Docket Item # 8  
BAR CASE #2006-0023

BAR Meeting  
June 21, 2006

**ISSUE:** Demolition/encapsulation

**LOCATION:** 326 South Pitt Street

**Figure 1** Existing rear elevation

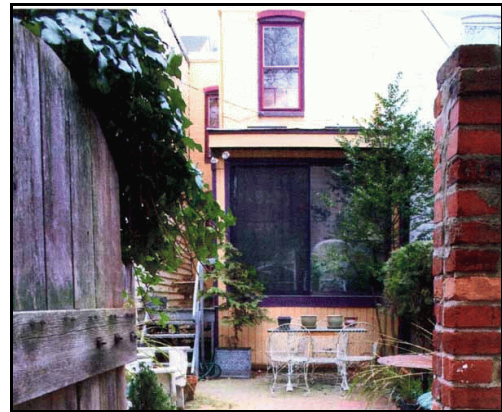
Staff does not believe any of the above criteria are met. The one story addition that is to be demolished is not historic. It appears to post date the apparently smaller addition seen on the 1941 Sanborn Atlas. Certainly the present appearance of the addition, with T-111 siding and full height windows, is that of the latter part of the 20<sup>th</sup> century. While the rear wall of the historic rear ell will be encapsulated, it has been encapsulated previously and there will be no new demolition of this brick wall. Staff commends the applicant for retaining the dogleg. Although the dogleg will not be visible to the public once the new addition has been constructed, the original footprint and massing of the house will be retained and will be visible from the interior of the property.
